TO: Mercedes-Benz Dealer Principals, General Managers, Sales Managers, Service Managers, Parts Managers	FROM: Gregory Gunther, Department Manager, Vehicle Compliance and Analysis, Engineering Services
RE: <b>Recall Campaign Launch Notification</b> <b>Check Wiring Harness for Second Seat Row Right</b> <b>MY20 167 (GLE-Class)</b>	DATE: May 29, 2020

Campaign No. 2020050009, May 2020

SUBJECT: **Model GLE-Class (167 platform) vehicles**  
**Model Year 2020**  
**Check Wiring Harness for Second Seat Row Right**

Figure 1

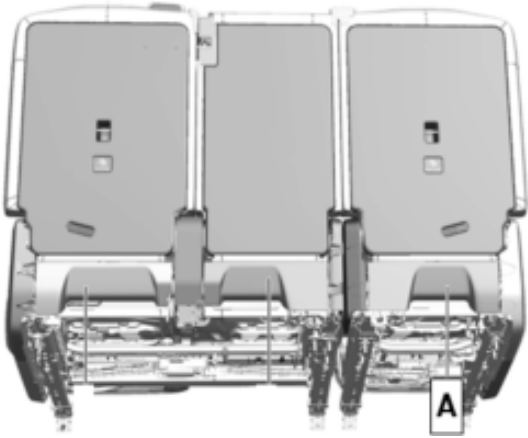
1. Remove the wiring harness cover (**A, figure 1**) of the right-hand second seat row (40% side).

2. Check to see if the mounting clip for the wiring harness is positioned **correctly** on the holder (**B, figure 2**).

**i** (Figure 2) shows the **OK** condition.

**i** The mounting clip may be positioned incorrectly on the holder and was installed so that it is turned by 90° (**C, figure 3, not OK**).

The wiring harness must **not** be in contact with the guide rail.

1. Cut through the cable strap for the mounting clip using a side cutting pliers.
  - i** The protective sleeve and individual lines must not be damaged when doing this.
2. Check the protective sleeve and the individual lines for damage.
  - i** Repair the wiring harness and/or the protective sleeve if they have been damaged.
  - i** Use fabric tape to repair the protective sleeve.
  - i** Use a line connector to repair the wiring harness.
3. Then use a new mounting clip to position the wiring harness correctly as shown in Figure 2.
4. Assemble in reverse order.
